Marriott Hotel at Cesar Chavez

Date: May 17, 2017
To: Austin Design Commission
From: Planning & Urban Design Working Group
Subject: Working Group Density Bonus Program review of "The Marriott Hotel at Cesar Chavez" for substantial compliance with the Urban Design Guidelines.
Meeting Date: May 12, 2017; 12:00 pm
Applicant: Richard T. Suttle, Jr.- Armbrust & Brown, PLLC
Architect: HKS

DESIGN COMMISSION WORKING GROUP COMMENTS REGARDING PROJECT'S COMPLIANCE WITH URBAN DESIGN GUIDELINES

10'-0" R.O.W. ENCROACHMENT UNDER CESAR CHAVEZ (LEVELS B2-B4)

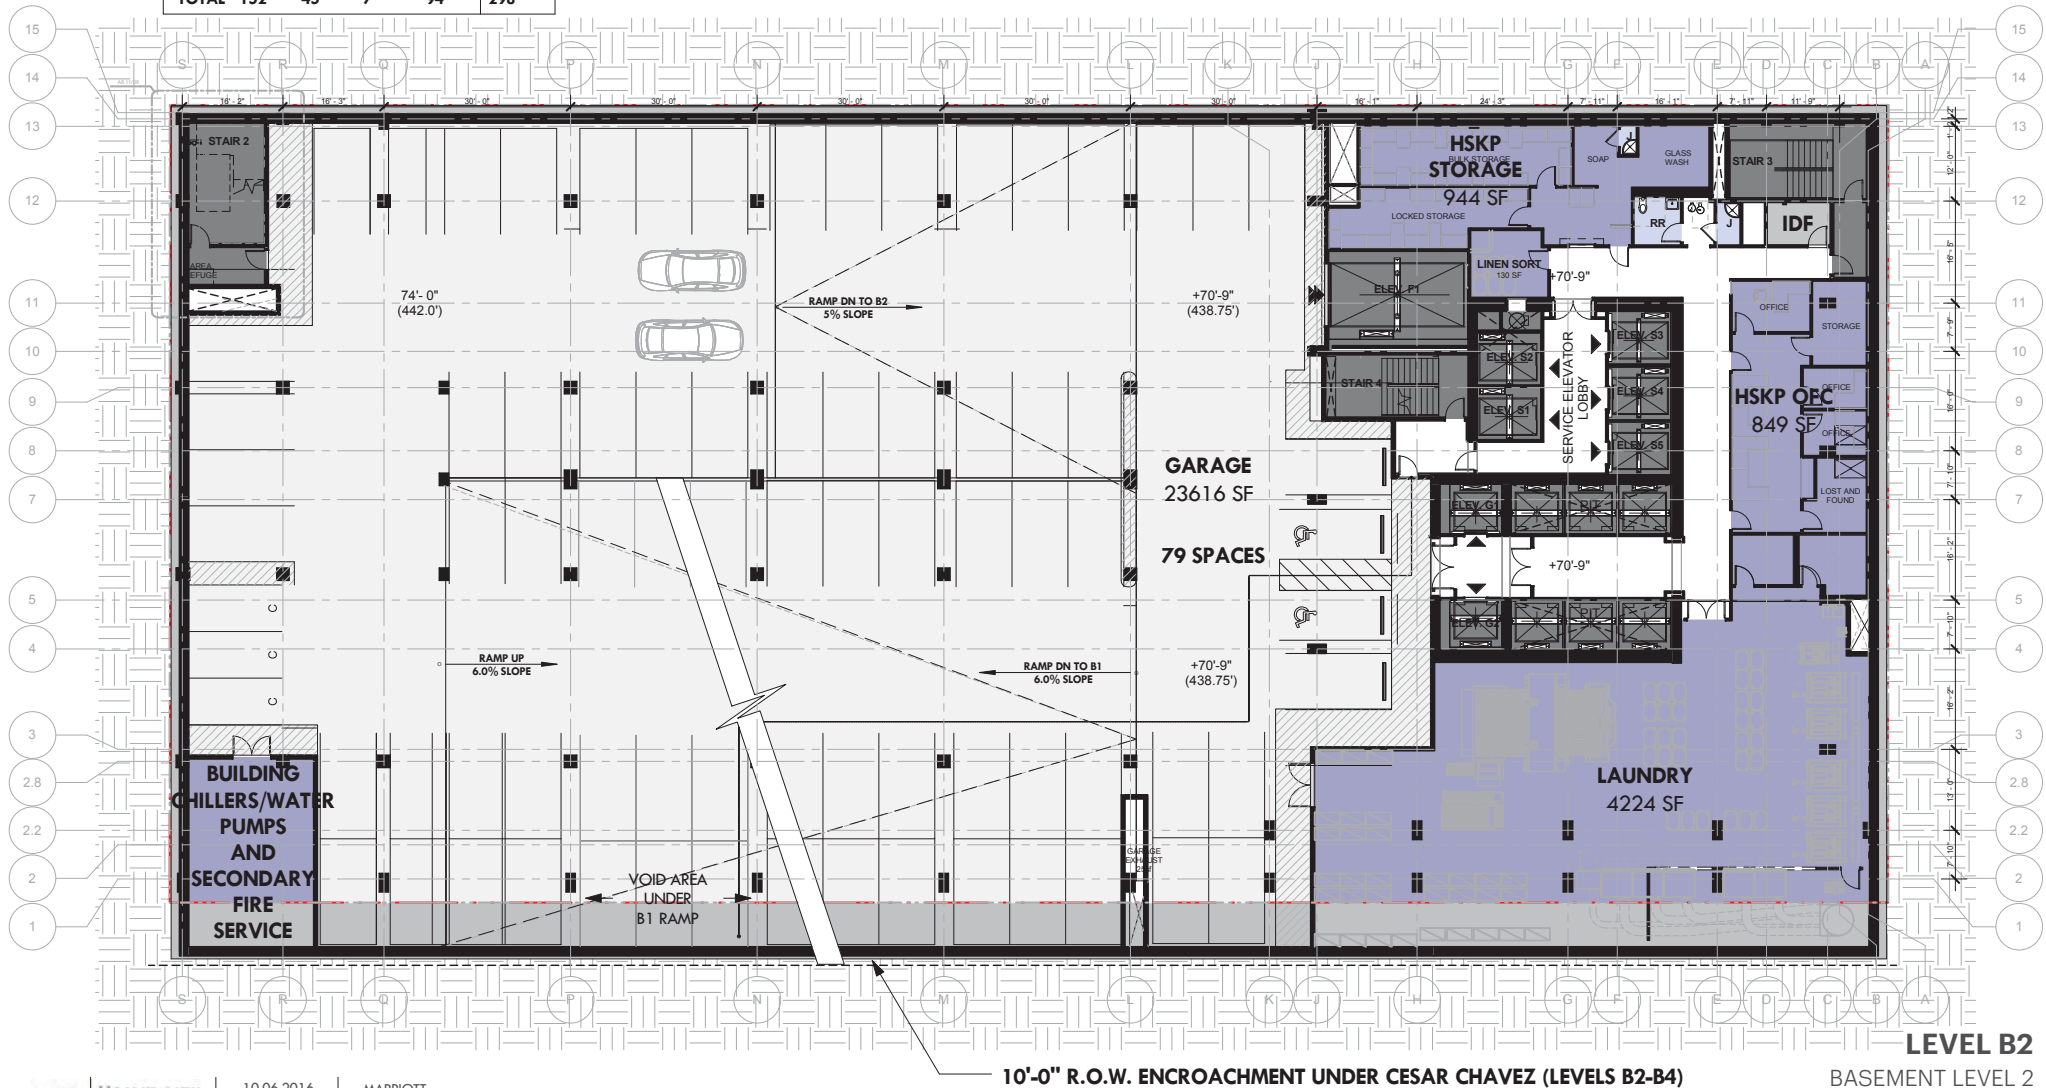
- Building encroachment into ROW on east about 8' into 20' walk. Concerns about view corridor in street and overhang impacts on street trees.
- Non-active east façade at level 1, 2. Applicant proposes using glass for a more interesting material, not solid wall/door material.
- Non-active façade to west at stairs at level 1. Applicant proposes using glass for stair walls/doors and implementing a branded elevator to provide access to public space at the roof.
- Visibility is limited for vehicle exit onto alley. This could be a safety issue.
- Amount of vehicle space at south west corner at ground level is not pedestrian friendly, so it is important to have the food trailer shown, or notch out corner for a tree and green space.

LANDSCAPE CITY SUBMITTAL
PLAN

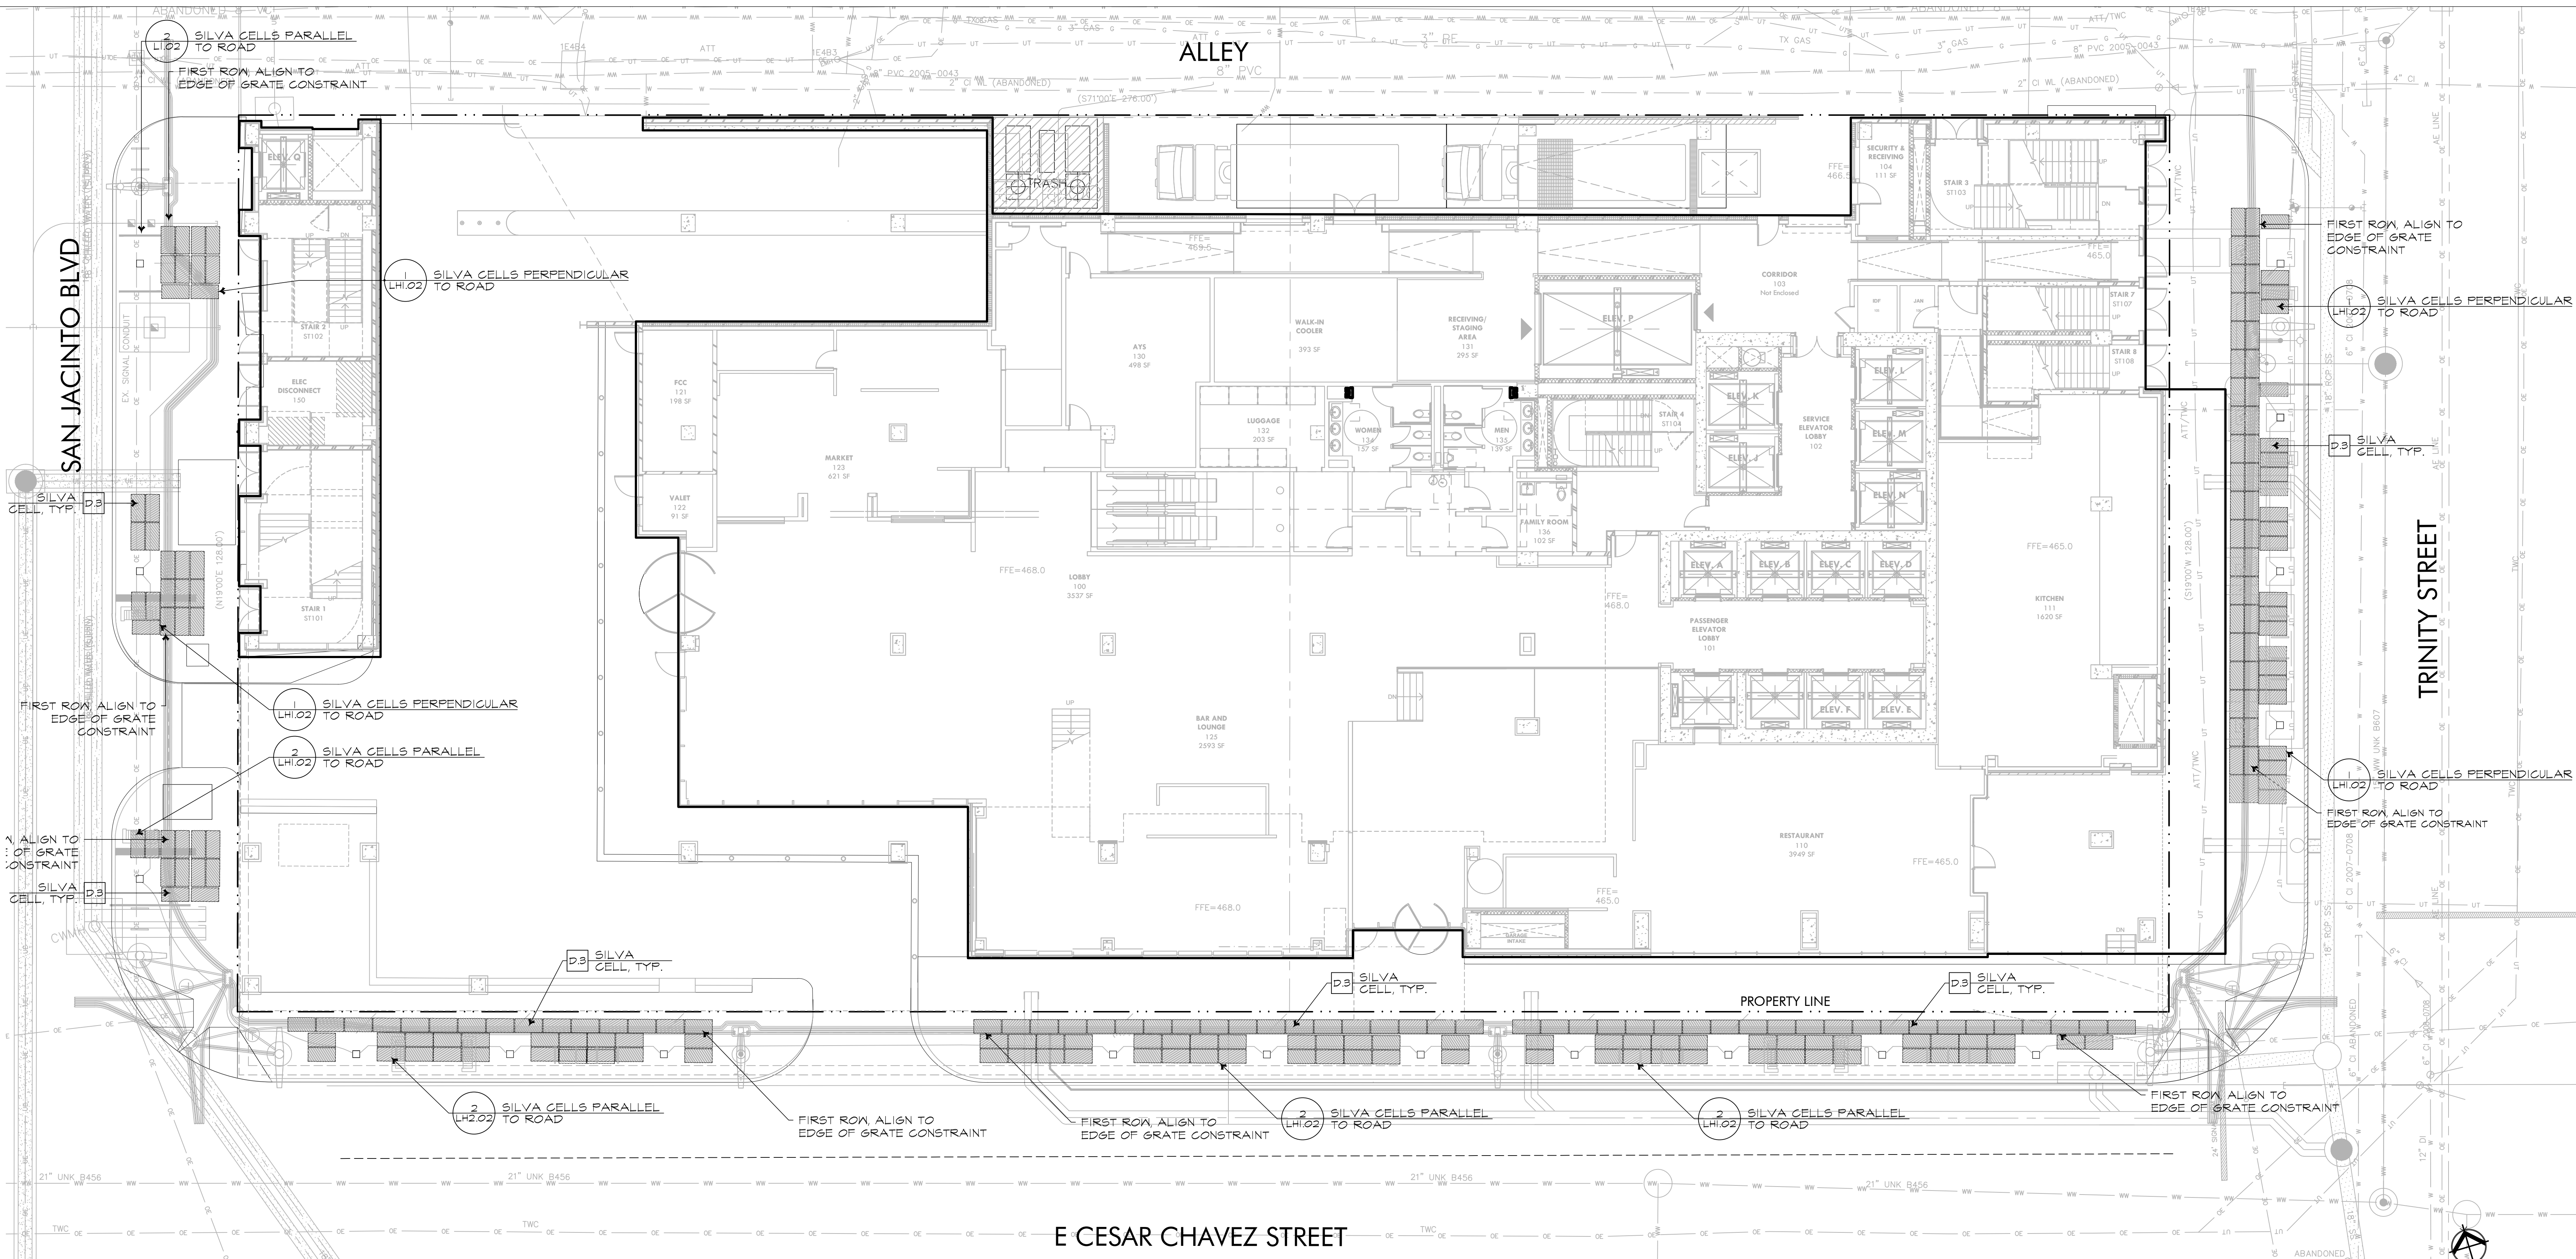
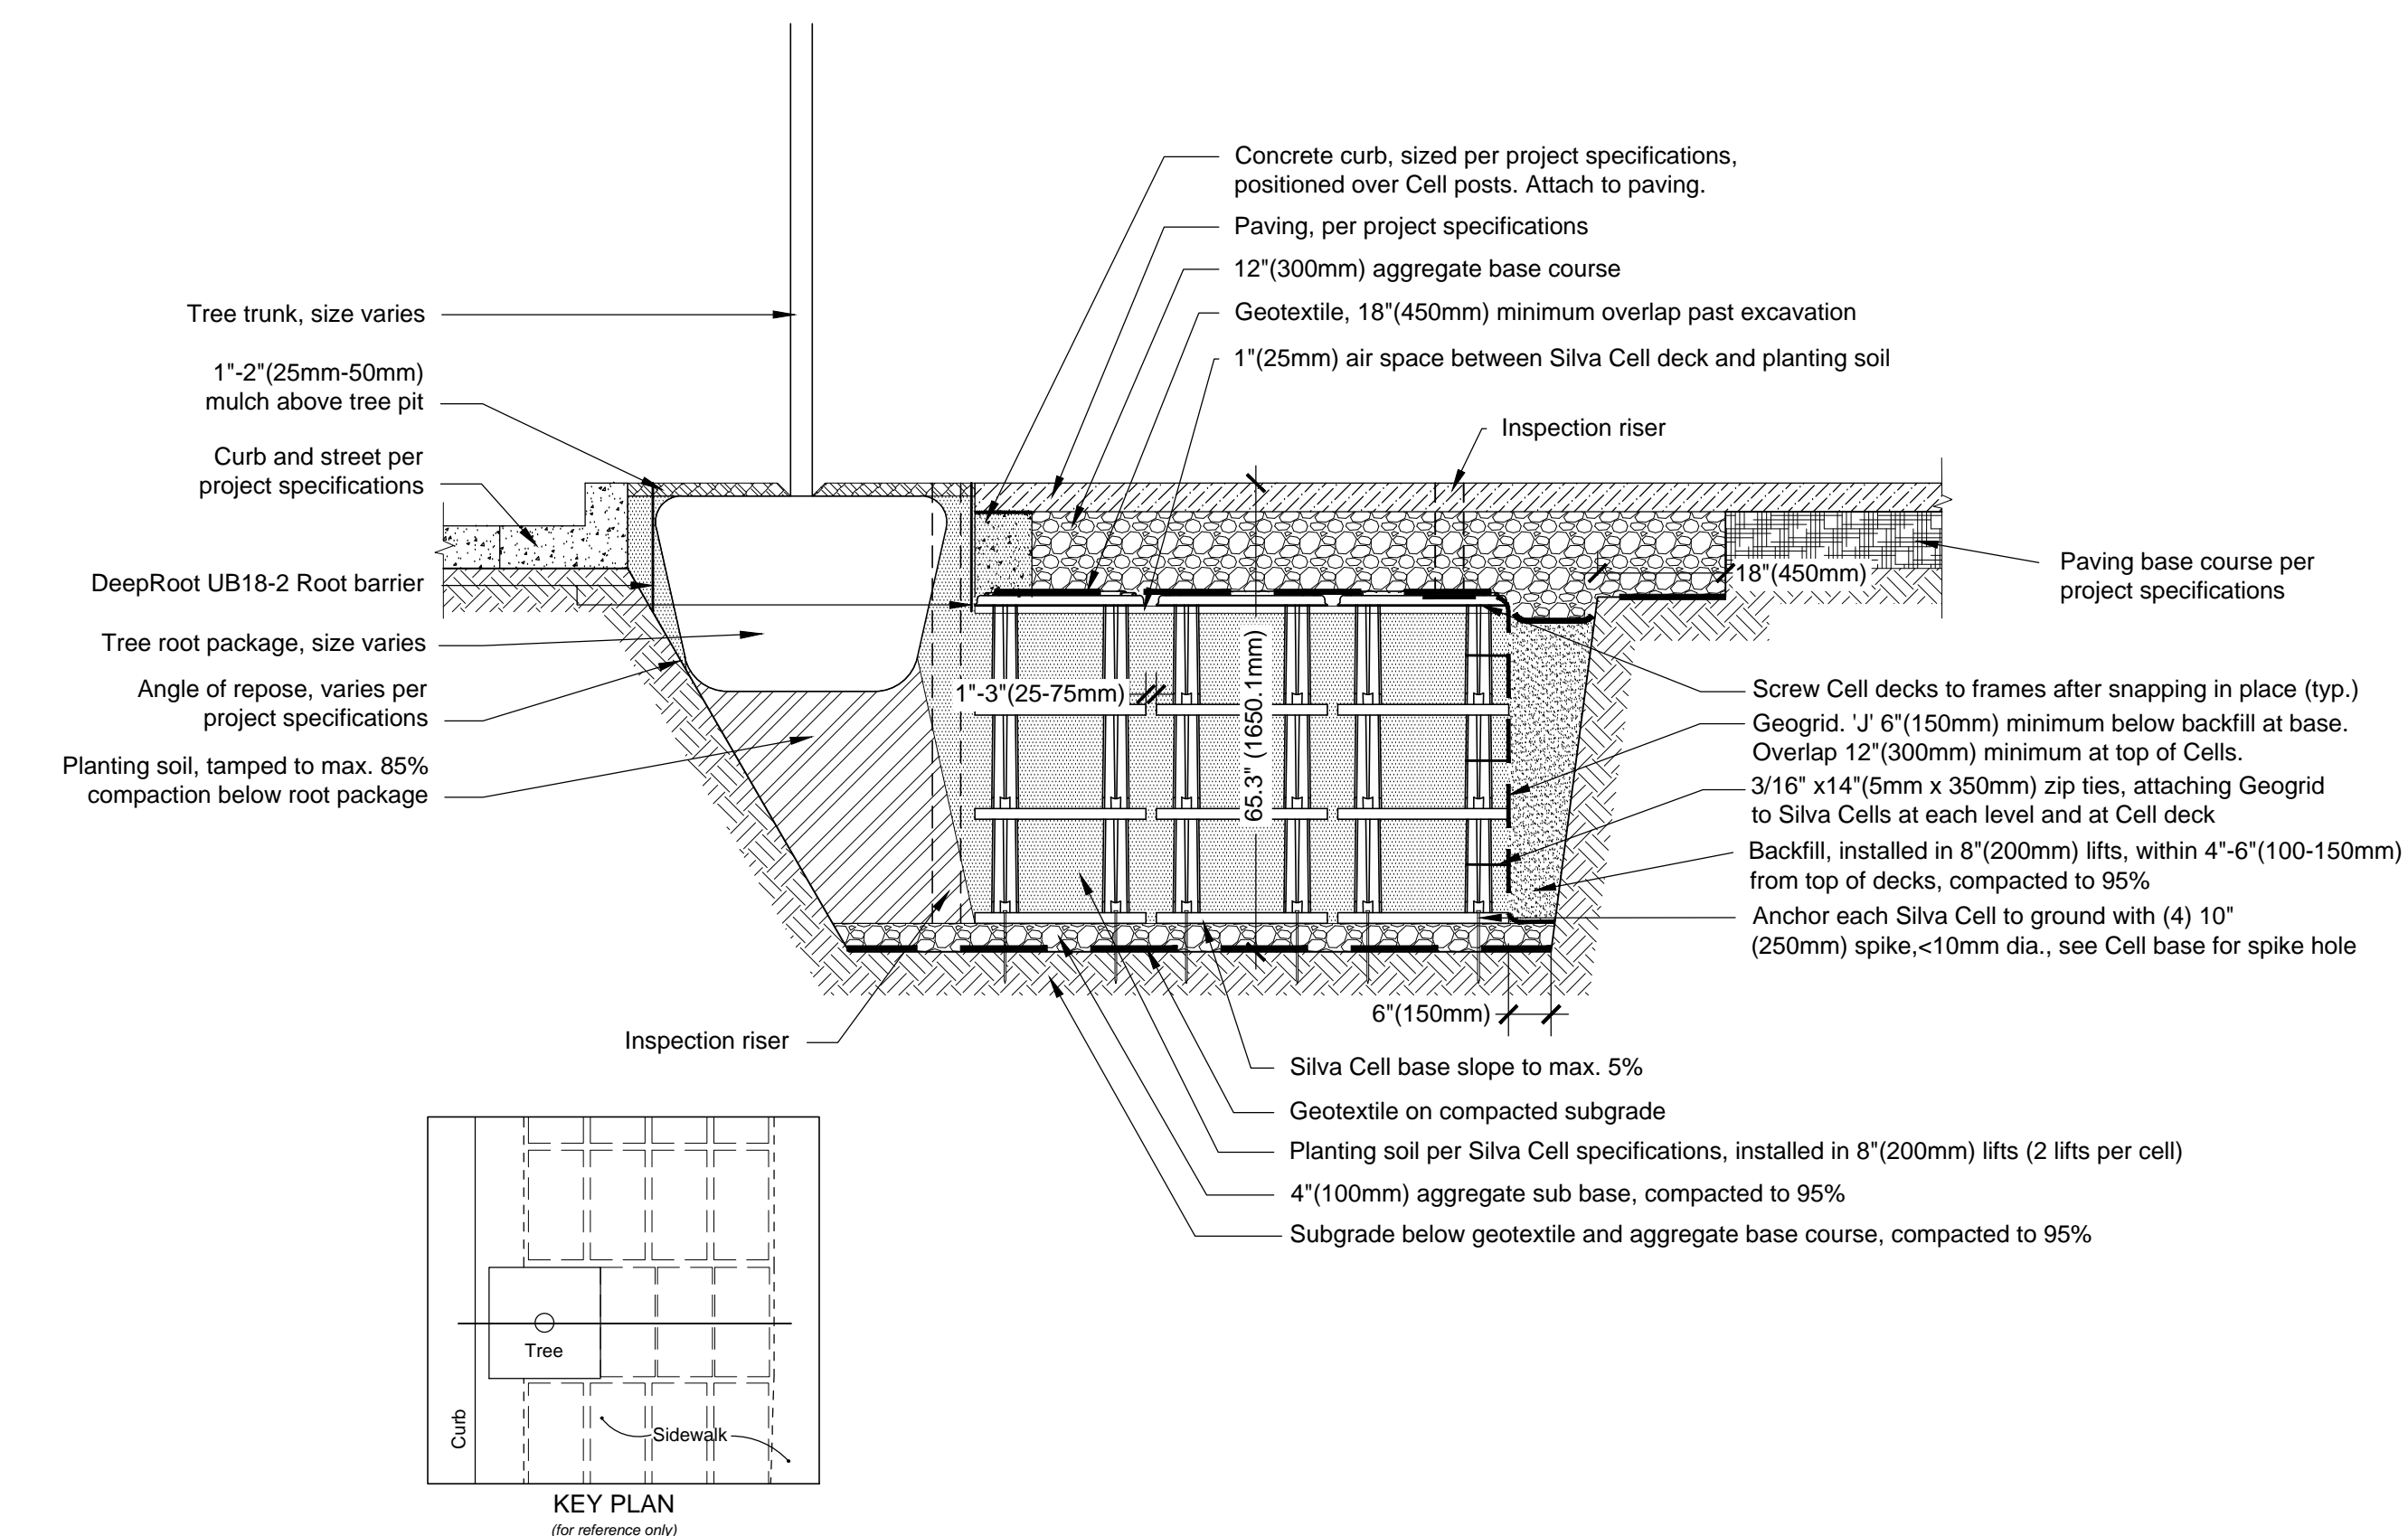
- The large tree in the middle of the property is a 40" Hackberry which is not a Heritage Tree species. We are mitigating the removal inches at the 300% mitigation rate.
- The trees along Trinity range from 13"-19". Given their location on the property line and the desire to construct sub-grade parking, the critical root zones would be impacted. There were also construction sequencing, traffic control challenges in this location and tower crane location considerations, which led to the decision to remove and mitigate the trees.
- In order to meet the Code required mitigation for these trees, we would be required to pay \$15,300 into the Urban Tree Fund. Through our coordination efforts with Keith Mars, Humberto Rey and various other reviewers, we arrived at the proposed plan (outlined below) as the most favorable option.

- Great streets compliance on Cesar Chavez, Trinity and San Jacinto
- 5", Bigtooth Maples on Trinity Street
- 5", Red Oaks on San Jacinto
- 5", Live Oaks on Cesar Chavez
- White Lodging has also committed to Silva Cells along each street, to aid in faster growth, larger canopies and more mature trees. The cost estimate values the upgrade to the suspended pavement system to be approximately \$74,043, in addition to the trees being planted. See attached cost estimate provided by DeepRoot Green Infrastructure, LLC and the corresponding design plan.

The mitigation plan will result in more trees than currently exist, a consistent great streets pedestrian environment on all adjacent public street frontages, and offer a better design and public realm experience. This mitigation plan is the result of many conversations, meetings and discussions with Keith Mars. The value of the mitigation is also nearly 5X that of meeting the Code minimum and paying into the tree fund.
